PD Measurement Baseline

Yan Zhuang, Huawei Technologies

- According to L2 ad hoc discussion, propose baseline text for PD measurement for IEEE 802.3bt

New TLVs for PD measurement

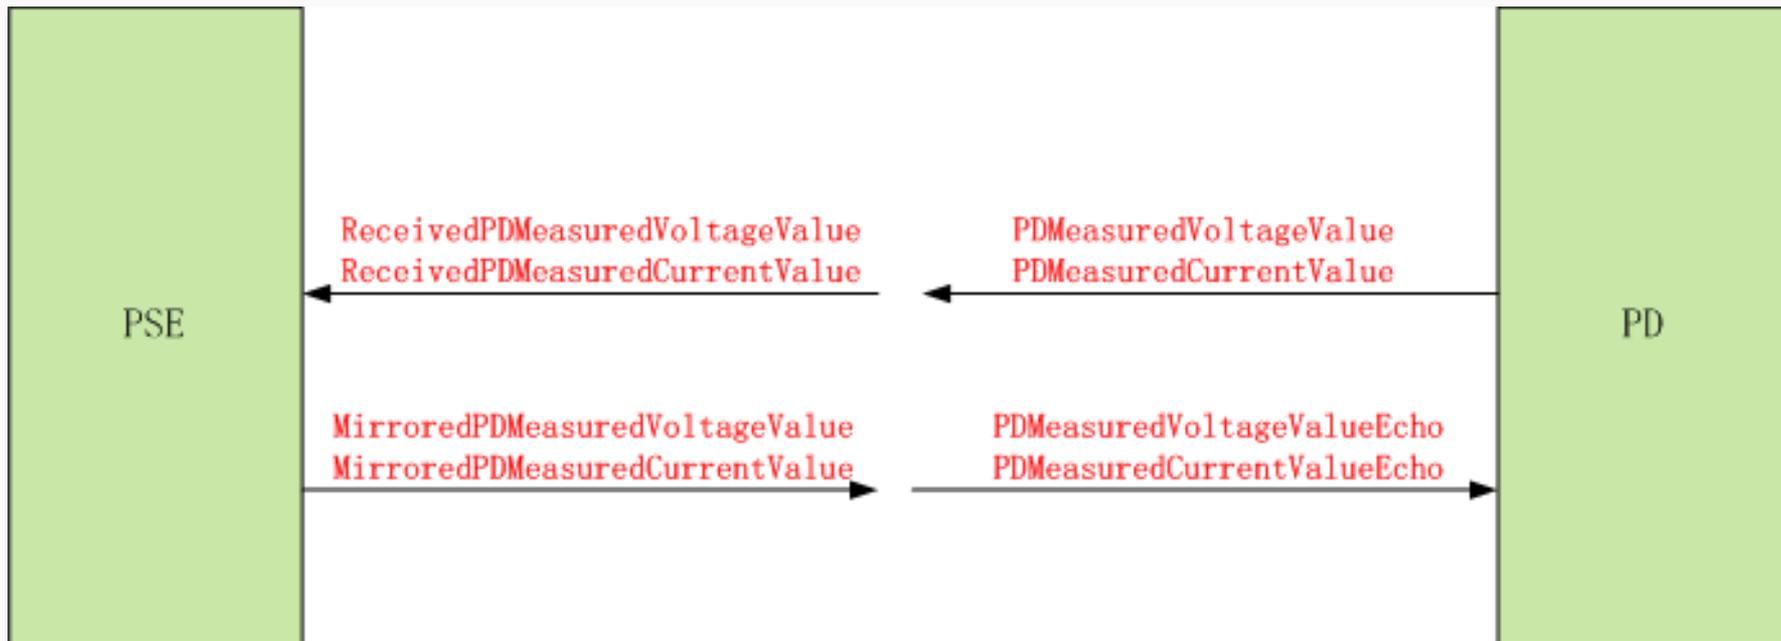
V_{PD} and $I_{port-PD}$ TLV

Enable a PSE to request the measured V_{PD} and $I_{port-PD}$ from the PD. This can be used to calculate retracted power on the cable.

Bit	Function	Value/meaning
15:0	V_{PD}	$V_{PD} = 0.1 \times (\text{decimal value of bits}) V$ Valid values for these bits are decimal 1 through 570

Bit	Function	Value/meaning
15:0	$I_{PORT-PD}$	$I_{PORT-PD} = 0.1 \times (\text{decimal value of bits}) mA$ Valid values for these bits are decimal 1 through 9000
